Application Number: DM/24/3034 (Erection of detached dwelling with attached garage, associated parking and new access from Ockley Lane (Revision of application DM/23/2741)

Comment: Objection

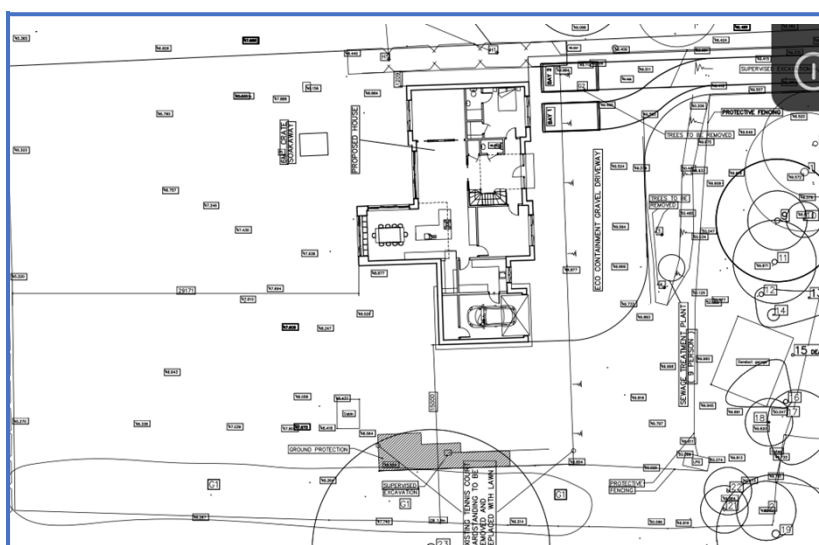
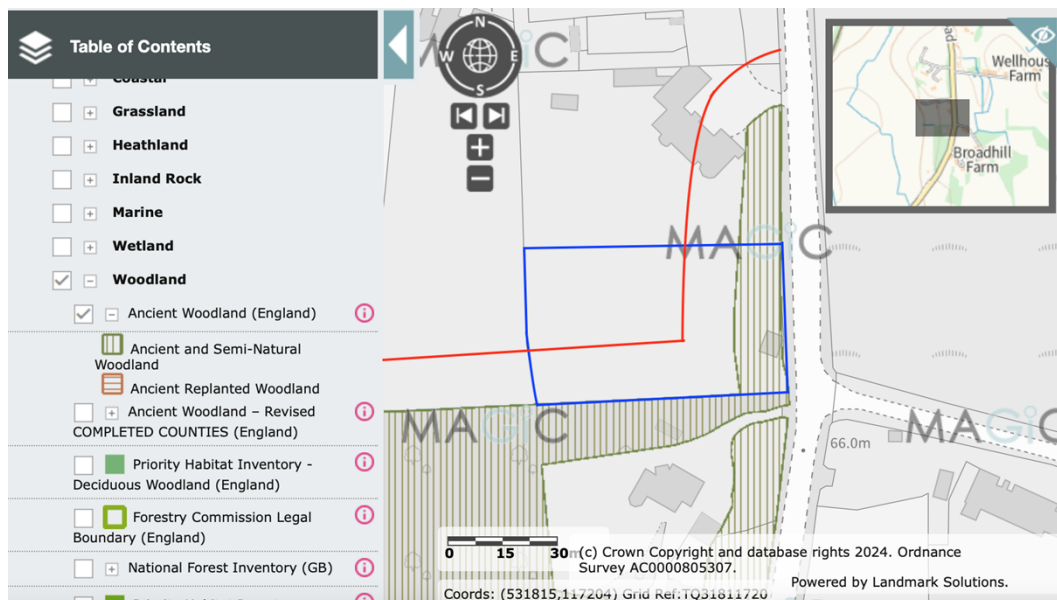
The planning application fails to illustrate the position of the proposed 5 bedroom property and the access in relation to the ancient and semi-natural woodland (ASNW) to the East as well as the South of the site, and the 15m buffer zone around the whole woodland (buffer zone based on the governments 'Ancient woodland, ancient trees and veteran trees: advice for making planning decisions'). This is illustrated utilising the DEFRA MAGIC map below (the site is denoted in blue and the ASNW 15m buffer zone is in red) followed by a copy of the proposed design for ease of comparison.

Please note the proposed access through the ancient and semi-natural woodland and the position of the storm water sewer/ drain, sewage treatment plant as well as the gravel driveway in the 15m

ASNW buffer zone. The application suggests the “eastern boundary of the site may not be ancient woodland and the ecological survey did not record any woodland on site only a treeline with disturbed ground cover.” The government's Ancient woodland, ancient trees and veteran trees: advice for making planning decisions states that ancient woodland is any area that's been wooded continuously since at least 1600 AD. 'Wooded continuously' does not mean there's been continuous tree cover across the whole site. Not all trees in the woodland have to be old. Open ground, both temporary and permanent, is an important component of ancient woodland. Where a proposal involves the loss or deterioration of ancient woodland you should not take account of the existing condition of the ancient woodland or ancient or veteran tree when you assess the merits of the development proposal. Its existing condition is not a reason to give permission for development. A woodland or tree in poor condition can be improved with good management. A 15m buffer zone to protect the ASNW has been used but it is worth noting that the advice for making planning decisions highlights larger buffer zones are likely to be needed if the surrounding area is less densely wooded, close to residential areas or steeply sloped.

Despite the application stating that “The new access point proposed will cut through a tree-line that is in the designated ancient woodland as per the Magic Map dataset. However, no trees will be removed as part of the new access point and the access has been designed to minimise the need for trees to be removed.” The Arboricultural Implications Report & Method Statement includes a table of tree removals; all 3 of which the reason for removal are due to either proximity to access the driveway or within the access driveway.
